SUBJECT: Nine Mile Point Nuclear Station
Unit No. 2; Docket No. 50-410

Supplemental Information Regarding Nine Mile Point Nuclear Station, Unit No. 2 –
Re: The License Amendment Request for Extended Power Uprate Operation (TAC
No. ME1476) – Steam Dryer

ATTACHMENT 1
SUPPLEMENTAL INFORMATION REGARDING LICENSE AMENDMENT REQUEST FOR
EXTENDED POWER UPRATE OPERATION
(NON-PROPRIETARY)

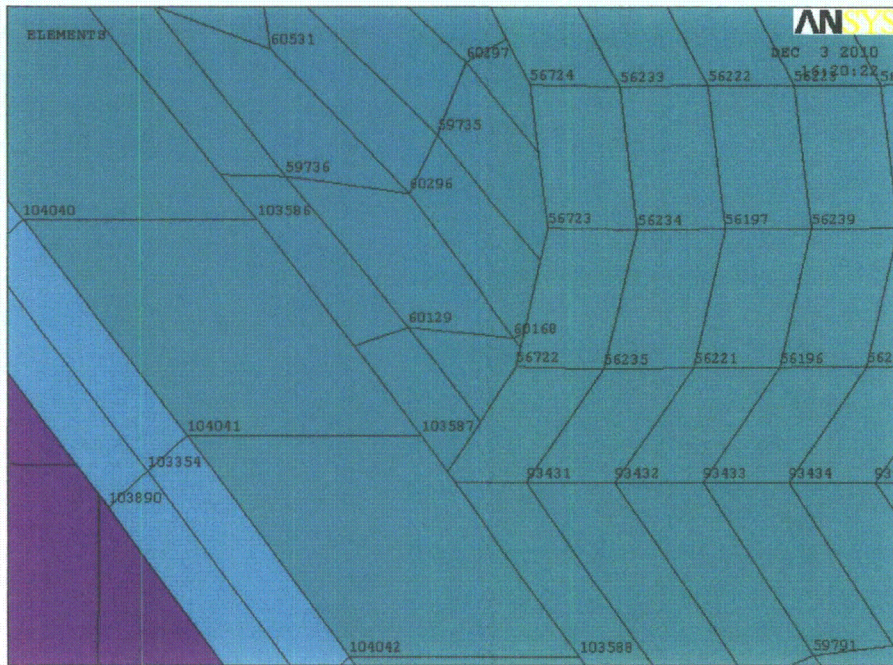
NRC Question No. 2. Compare stress distributions between the global and sub-models.

Tables RAI-21 S01 - S1 and RAI-21 S01 – S2 list the component stresses at the maximum stress stations for two points on the drain channel (the component that is most highly stressed). The first point (node 56724) is on the bottom edge of the drain channel and the second point (node 56197) is located higher up on the drain channel and closer to the weld. These locations are selected because they are away from both the weld and the intersection boundaries. The stress distributions are provided prior to application of step 4 (discussed at length in the original RAI response), so that only the forces and moments extracted from the global model are applied to the perimeter edges. Both locations are depicted in Figure RAI-21 S01 - S1.

Stress component	Stress [psi]		
	Global	Shell submodel	Solid submodel
σ_{xx}	92.12	74.05	61.26
σ_{yy}	575.96	565.25	577.91
σ_{zz}	N/A (identically zero at free edge)		
σ_{xy}	191.39	203.04	188.63
σ_{yz}	N/A (identically zero at free edge)		
σ_{zx}	N/A (identically zero at free edge)

Table RAI-21 S01 – S1 - Stress results at node 56724 at bottom of the drain channel

Stress component	Stress [psi]		
	Global	Shell submodel	Solid submodel
σ_{xx}	-28.00	-5.72	-8.36
σ_{yy}	-645.87	-659.20	-700.74
σ_{zz}	-293.98	-313.37	-317.99
σ_{xy}	38.11	56.16	75.81
σ_{yz}	-26.19	27.37	63.33
σ_{zx}	4.00	-2.17	-6.86

Table RAI-21 S01 – S2 - Stress results at node 56197
